**Rock Hill Schools
Rock Hill, South Carolina
STMS Cabling Upgrades
RFP # 22-2325 RHSD**

Addendum One – March 3rd, 2023

AP Placements

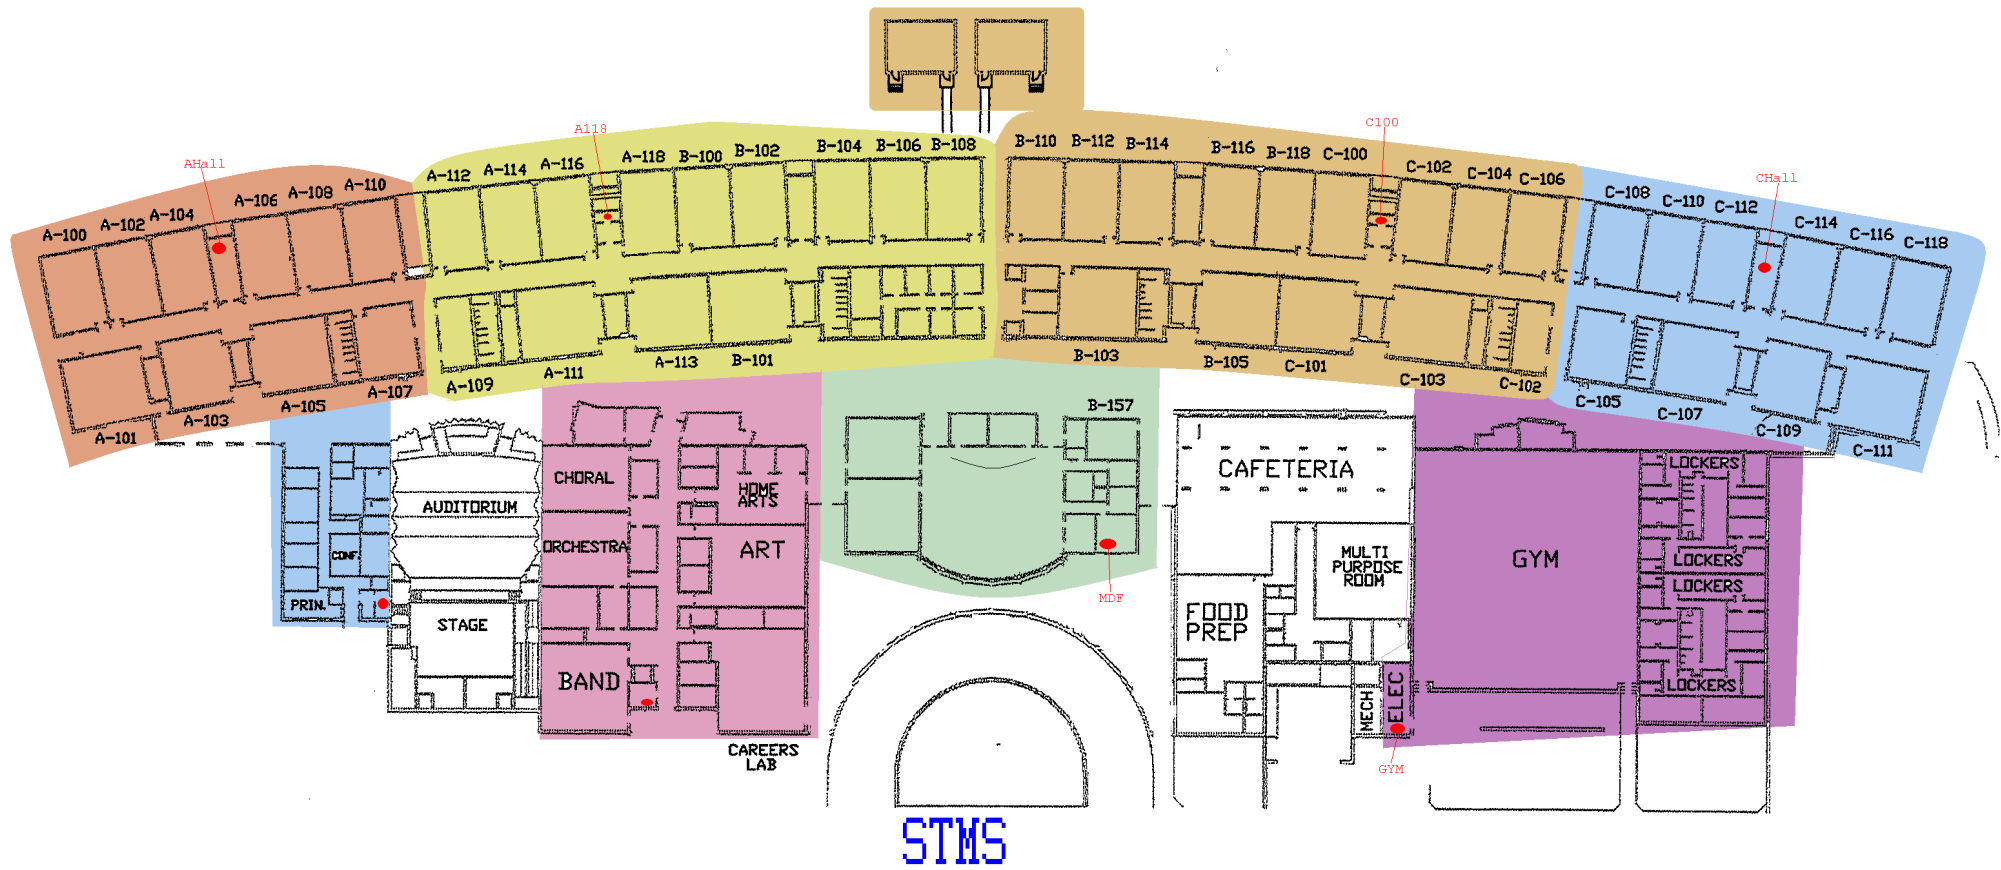
N5: Can RHSD provide vendors with a current map/ diagram and count of Access Points?

N5 Response: STMS has 75 Access Points, a map is attached to this addendum. The document is titled "STMS Access Point Diagram 08272021.pdf".
